Report to Sydney West Joint Regional Planning Panel

JRPP No:	2012SYW032
DA Number:	JRPP-12-223
Local Government Area:	Blacktown
Proposed Development:	The Ponds, Stage 4, Precinct 1 - Torrens title Subdivision creating 363 residential lots, 9 residue lots, 1 lot for school purposes, 3 lots for future open space purposes, 2 lots for future drainage purposes and new public roads with associated subdivision works
Street Address:	Lot 101, DP 1161271, Schofields Road, Schofields
Applicant:	Craig and Rhodes Pty Ltd on behalf of Landcom
Lodgement Date:	10 February 2012
Land Zoning:	R2 Low Density Residential, SP2 Local Drainage, SP2 Classified Road, SP2 Educational Establishment and RE1 Public Recreation pursuant to State Environmental Planning Policy (Sydney Region Growth Centres) 2006
Value of Development:	\$20,790,000
Number of Submissions:	Nil
Recommendation:	Approval
Report by:	Eltin Miletic, Town Planner
Instructing Officers:	Judith Portelli, Manager Development Services and Administration and Glennys James, Director City Strategy and Development

Date Submitted to JRPP:	26 June 2012
Date Considered by JRPP:	12 July 2012

Assessment Report

Figure 6. Proposed Subdivision with DCP road pattern overlay (Source: SJB Planning, 2012)

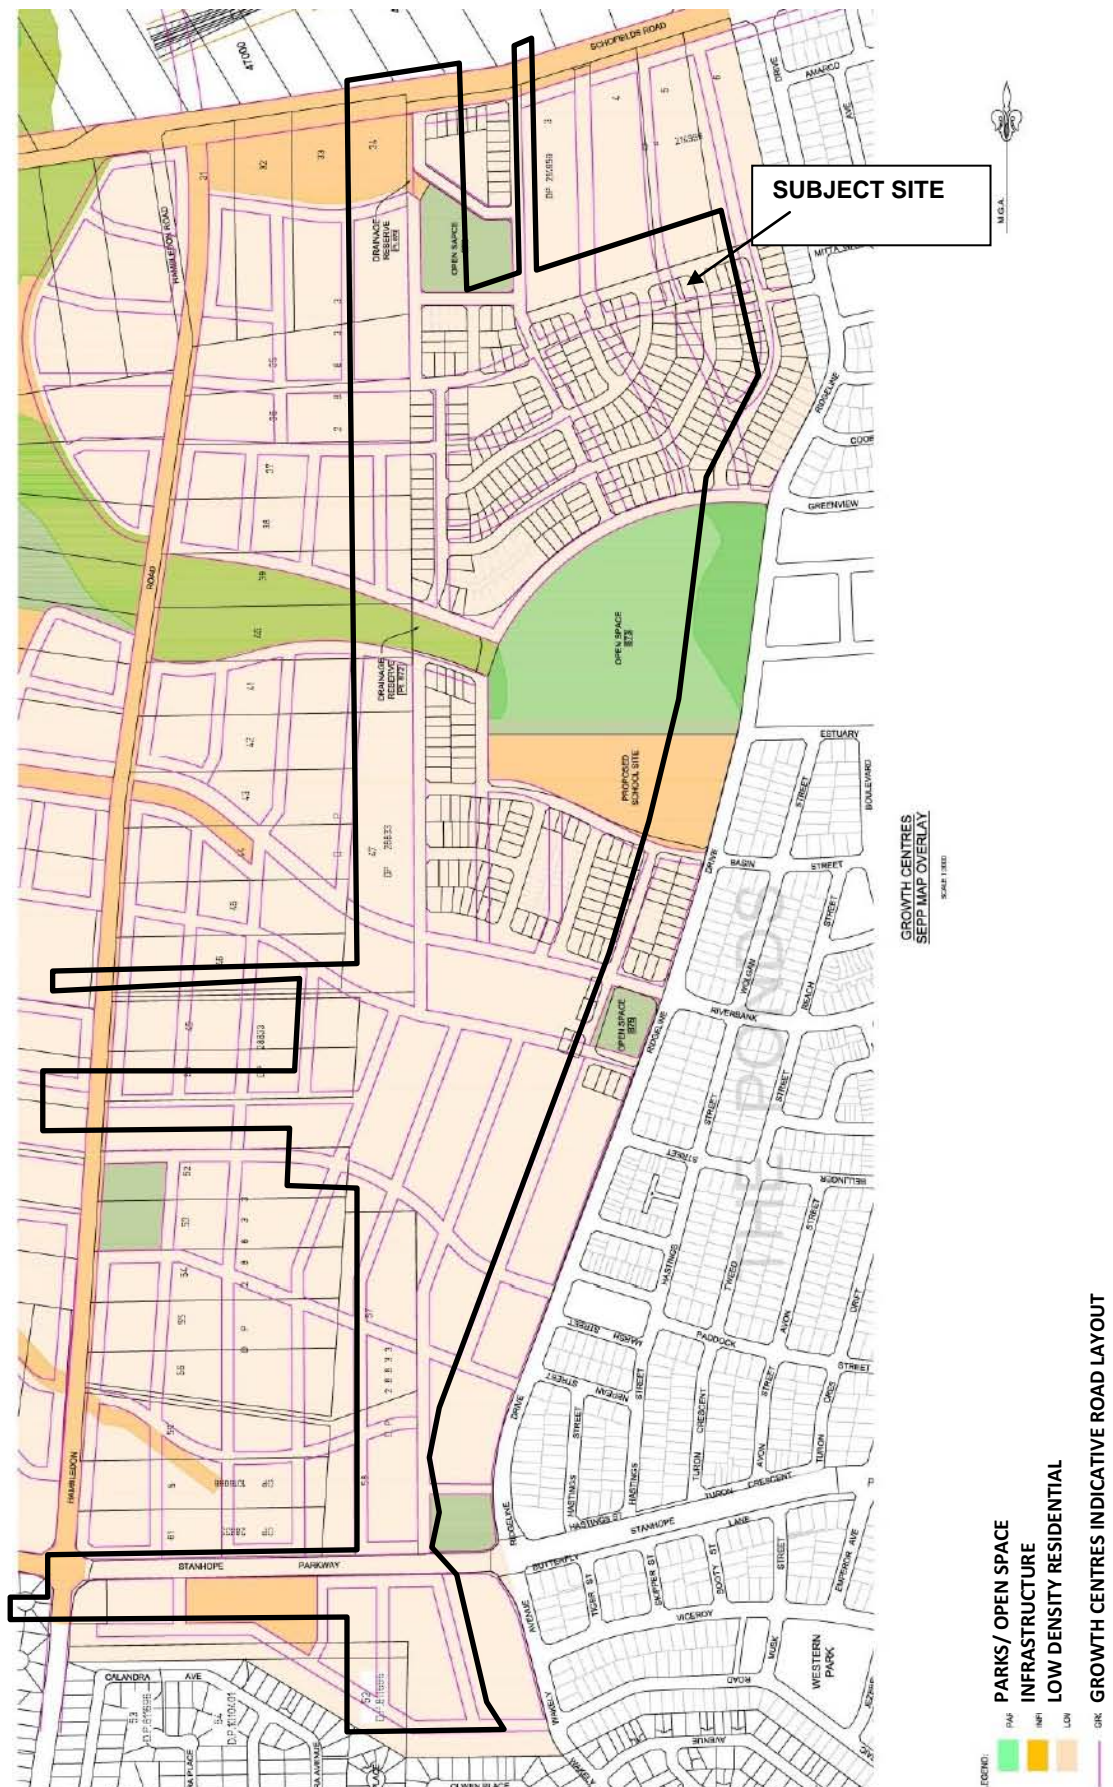
As a part of the DA, it is also proposed to vary the adopted DCP road pattern as shown on Figure 6 by:

- as noted above, upgrading the identified local road around the frontage of the future open space and school site to a collector road and provision of a link road connecting the northern part of the proposed collector road to the southern part fronting the future school site;
- creation of proposed public road along the southern frontage of adjoining properties to the north in order to avoid the creation of residual parcels of land requiring re-subdivision with adjoining land; and
- internal adjustments to the DCP road layout in order to provide a more efficient lot yield, which alters the identified future east-west access route to Hambledon Road.

A traffic statement prepared by Craig Hazell of Traffic Solutions Pty Ltd, dated 4 June 2012, was submitted as a part of the DA in support of the proposed variations to the adopted DCP road pattern. The proposed variations will not adversely impact the surrounding road network or the orderly development of any adjoining land and will facilitate a more efficient subdivision of the precinct. In this regard the proposed road layout and variations to the DCP road pattern were notified to all affected owners and no objections were raised to the proposed development. In addition, Council's Traffic Section has reviewed the traffic statement and the proposed road layout and raised no objections to the proposed development. Therefore, it is considered that the proposed road layout and variations to the DCP road pattern are acceptable and worthy of support.
